Request to Amend the Antioch-Priest Lake Community Plan: 2003 Update

Metro Planning Commission Meeting of 04/27/06

Sidewalk variance

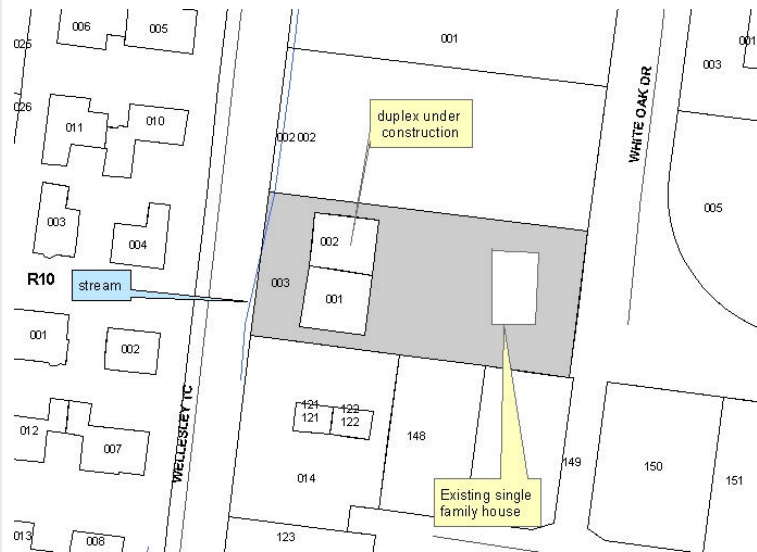
In the variance request, the applicant cites a “creek at the entrance of Wellesley Trace”, and a “falloff” of

topography as a hardship that would make the sidewalk unable to be built “at any price.” Metro maps *do* show the presence of a stream parallel to the frontage of proposed lot 1, near Wellesley Trace, and in a sidewalk constructability report Public Works has stated that sidewalk construction at the southwest property corner
